CWSP SYSTEM HARDENING FIELD SCOPING DOCUMENT

PM: [REDACTED]	Project Name: SH - BUCKS CREEK 1101 CB	
Notification: [REDACTED]	Region: Northern	City: Rock Creek
Project Manager: [REDACTED]	Division: North Valley	County: Plumas

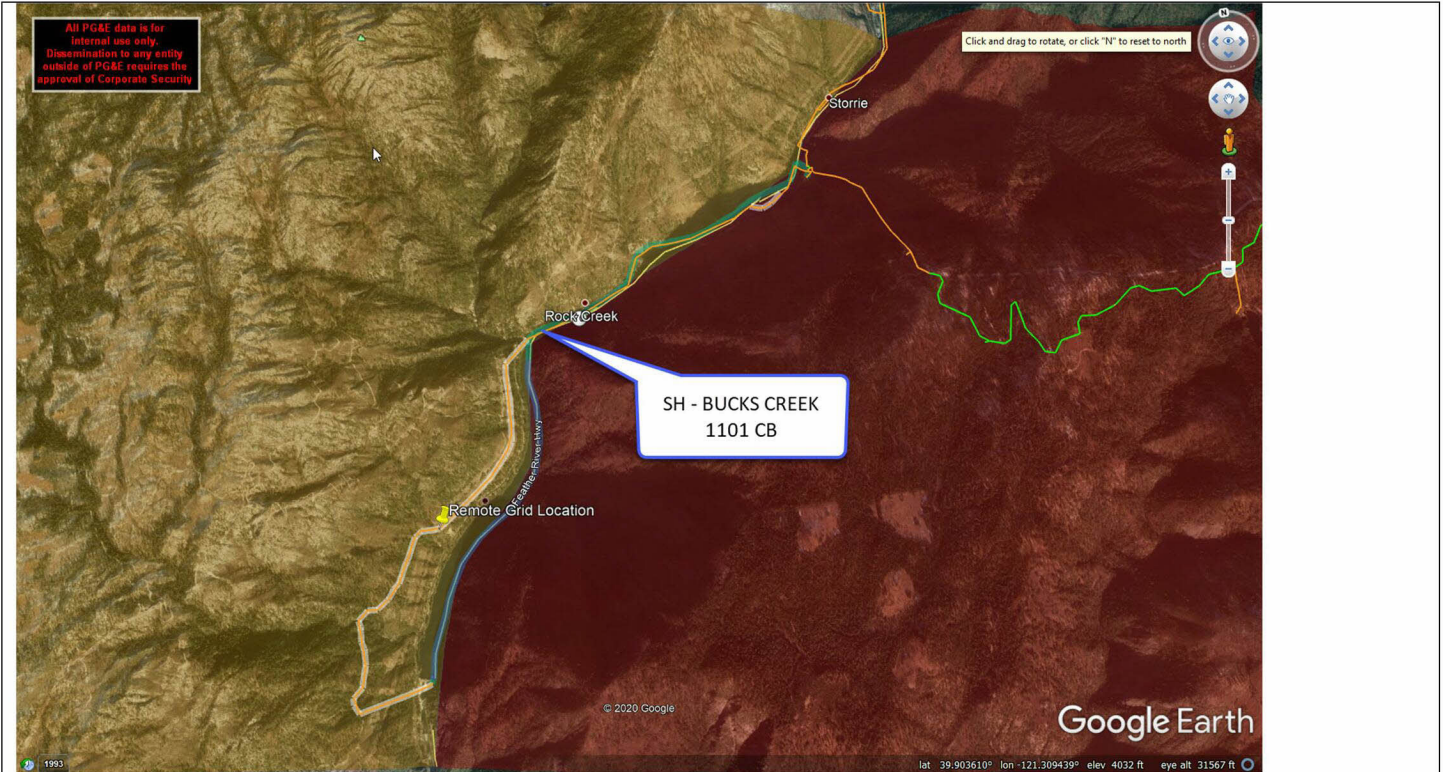
- This area has significant fire history directly impacting the project area. A 20 year look back at area fire history includes, the 56,000 acre Storrie fire (2000), 8,000 acre Poe fire (2001), 1700 acre Highway 70 fire (2001), 50,000 acre Butte Lightning Complex (2008), Canyon Complex (2008), 30,000 acre Chips Fire (2012), 154,000 acre Camp fire (2018) and the 320,000 acre North Complex 2020 all burned within the Feather River Canyon.

- Not all the fires were directly in the project footprint area; however, they show that this area is prone to significant, large fire history due in large part to steep, rugged, inaccessible terrain and periods of strong wind.

- The Feather River drainage is prone to daily diurnal winds and strong north/Diablo wind events at various times of the year, but most notably during the fall period when fuels are at their driest. These conditions have resulted in the area being affected routinely by PSPS events and has also resulted in many large, devastating fires originating in the Feather River drainage.
